Responses to NRC Letter Dated July 17, 1998

Request for Additional Information on the Reclamation Plan for the White Mesa
Uranium Mill

Source Material License SUA-1358

Re: White Mesa Uranium Mill
Response to NRC's Questions Dated July 17, 1998
Site Reclamation Plan

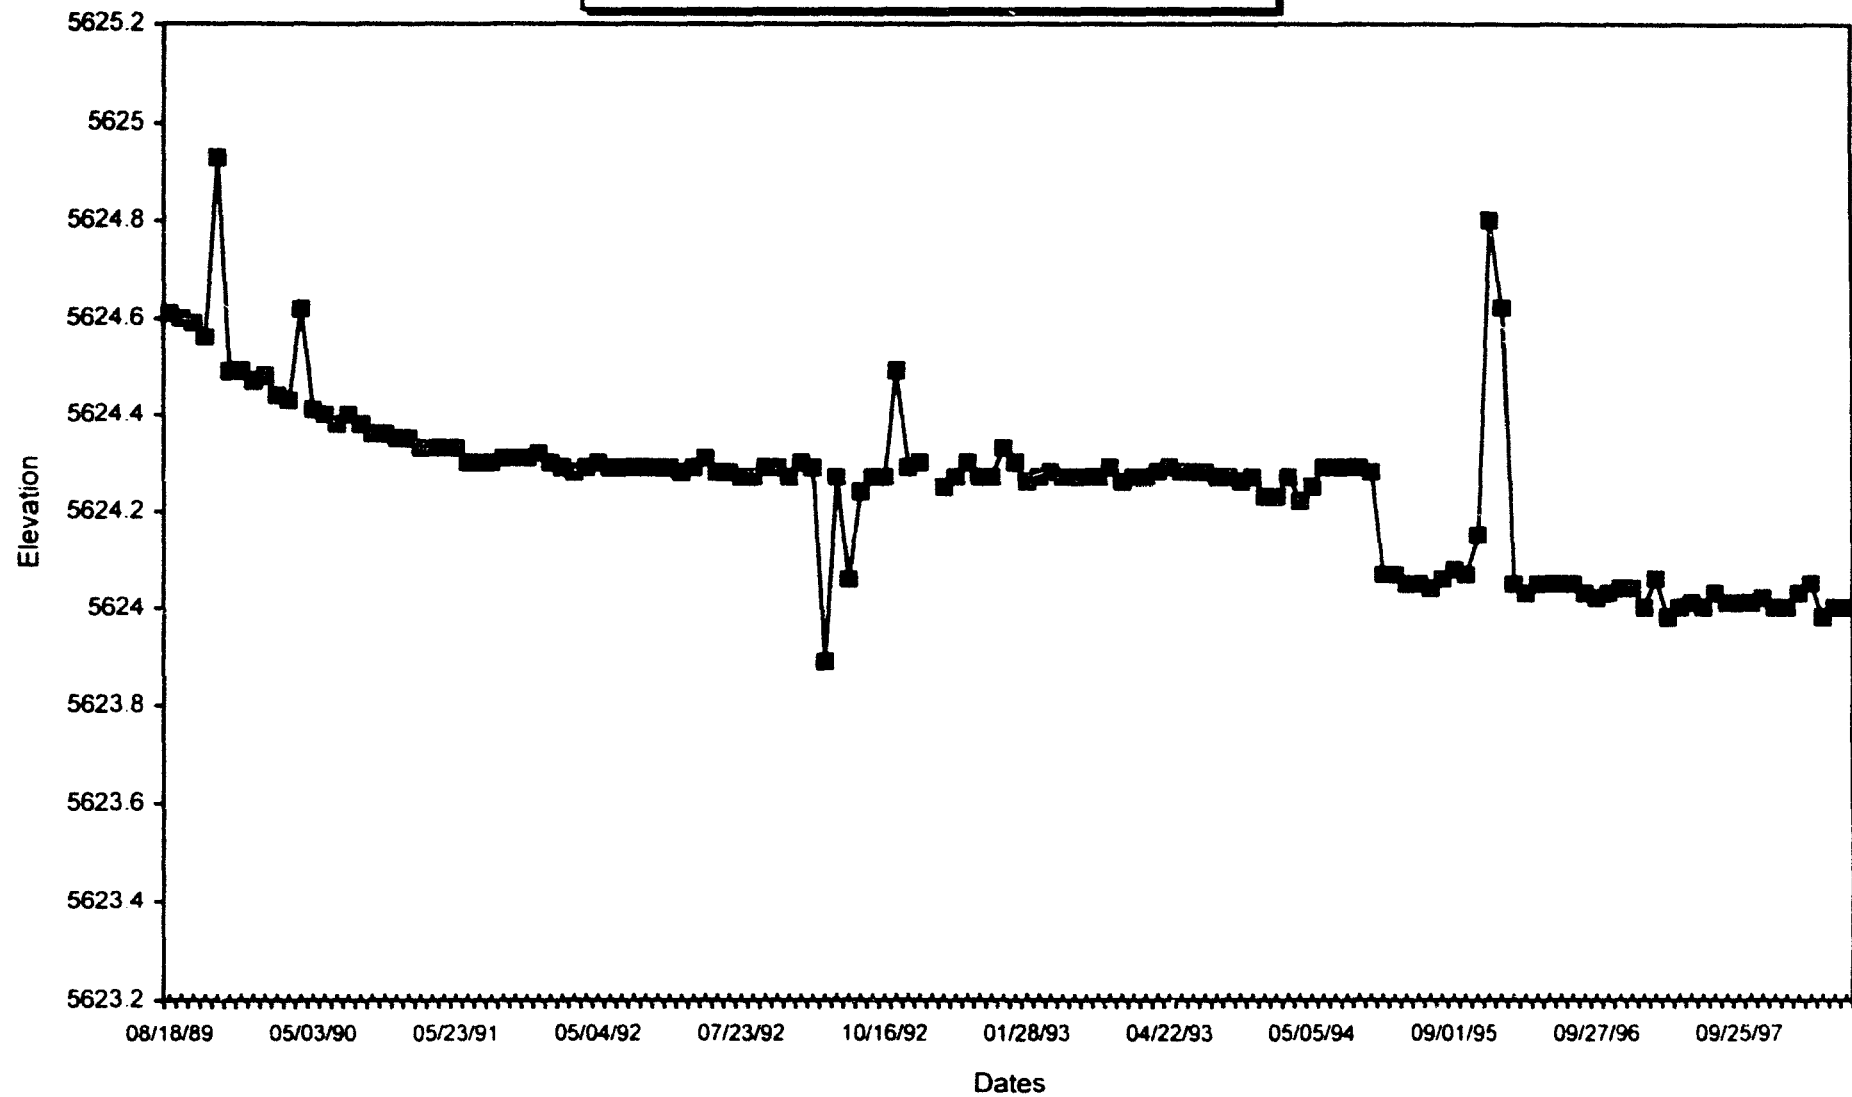
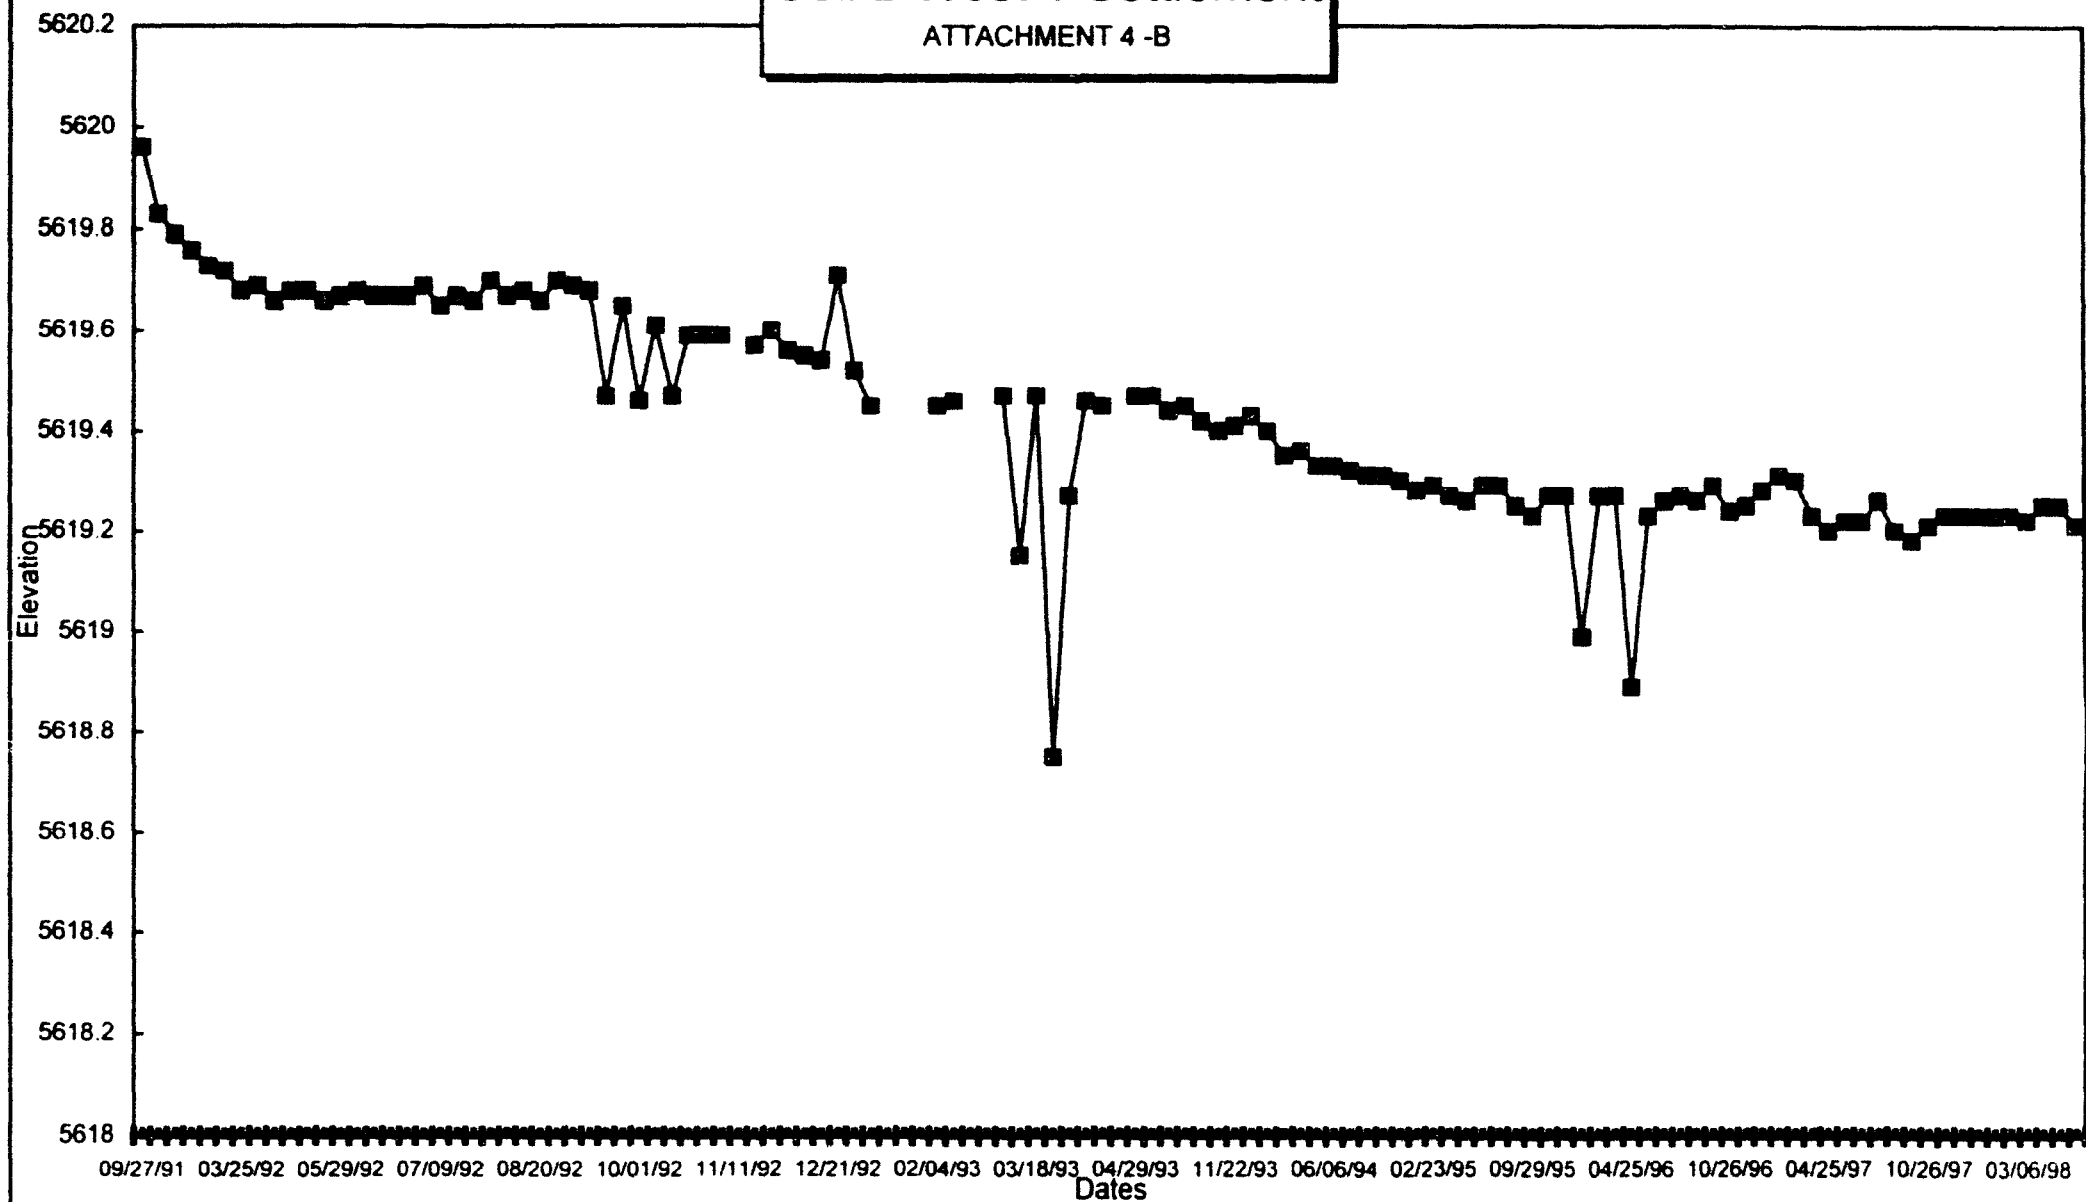
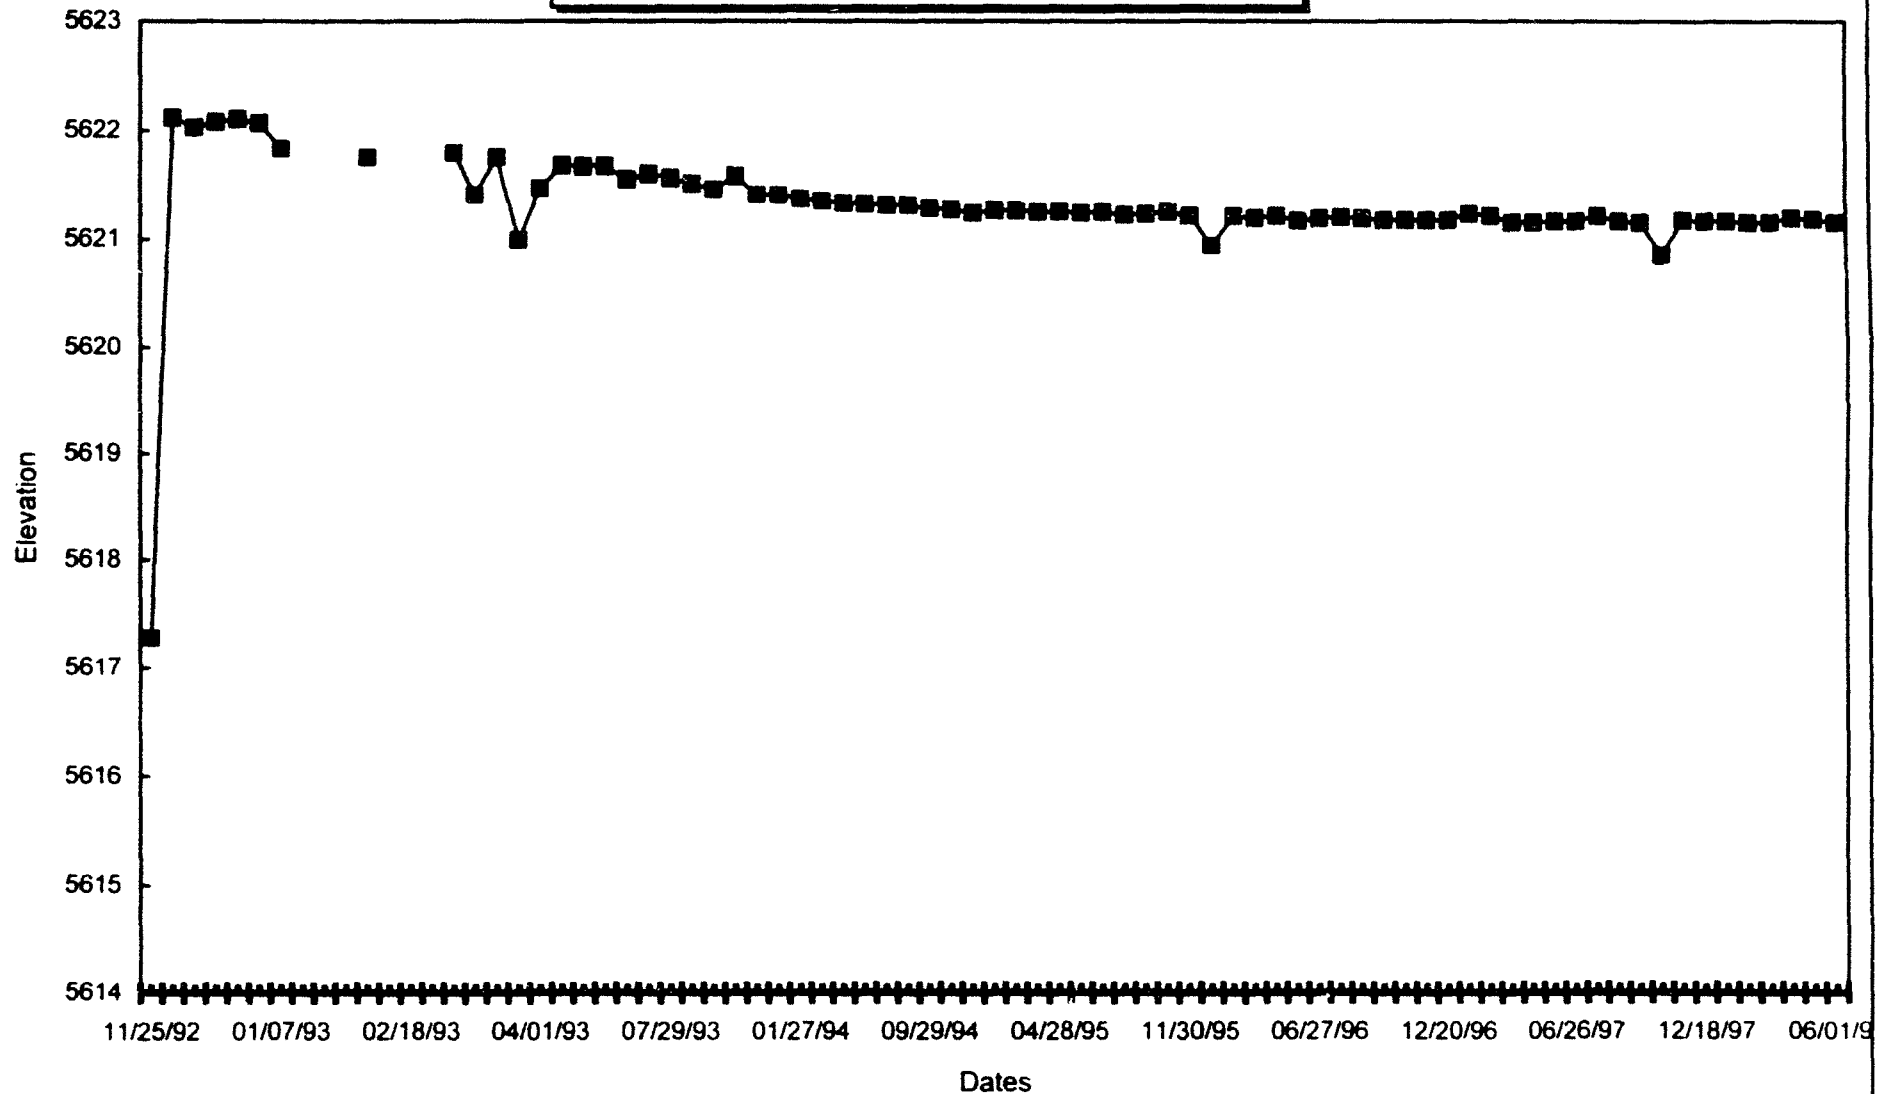
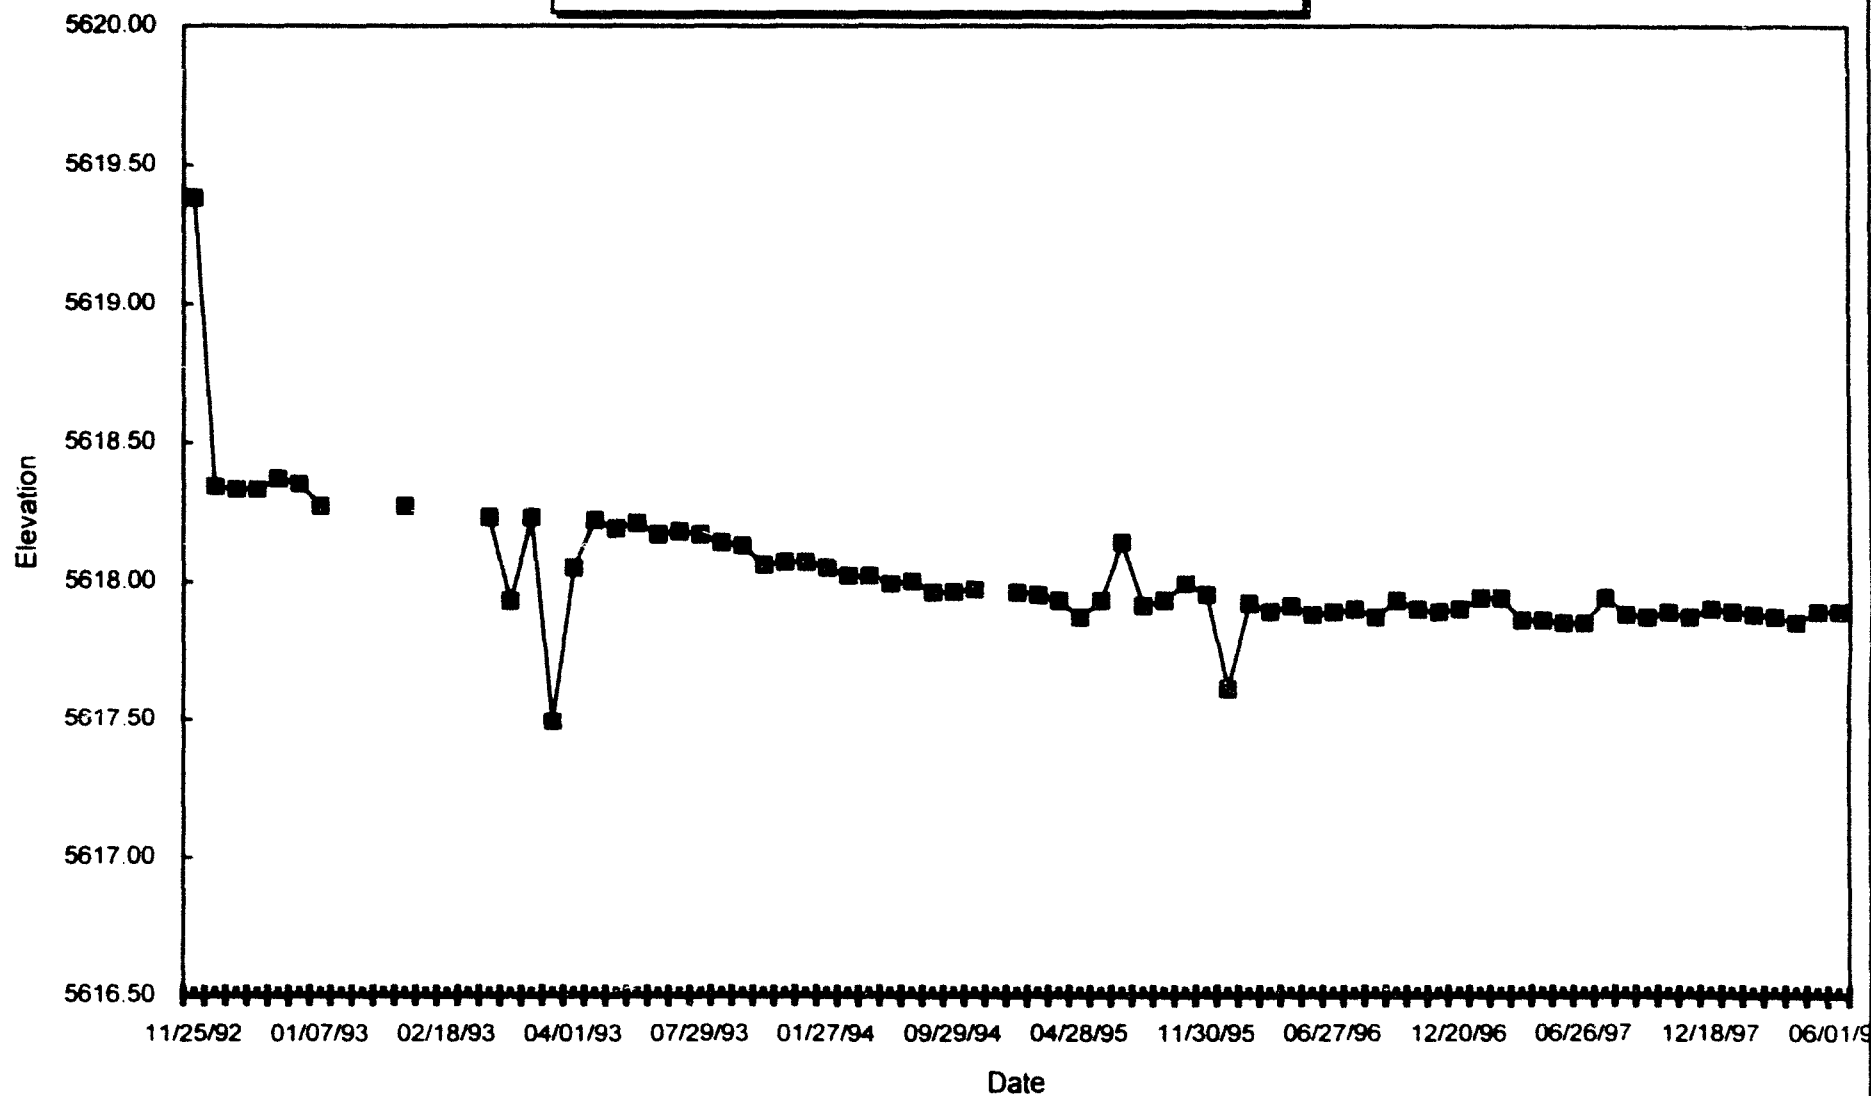
9. *Additional information and analysis are necessary in the calculation of the spatial variation of settlement and any potential for cover cracking due to this differential settlement. This calculation requires estimation of the settlement at various locations to provide an adequate areal coverage. Moreover, due to the heterogeneity of the tailings materials, a settlement analysis that takes into account the spatial variability of the material properties is indispensable to developing an adequate settlement monitoring program.*

As an alternative, HUSA proposes that settlement evaluation based on settlement monitoring is more appropriate for the White Mesa tailings than exploration and testing followed by calculations. Settlement data collected to date are shown in Attachment 4. Additional settlement monuments will be installed on a regular grid, illustrated in Figure 1 of Attachment 4, and measured on a schedule that will provide data to evaluate settlement rates and patterns. From these data, estimates can be made of the amount of settlement to be expected and the time until 90% of primary settlement is achieved.
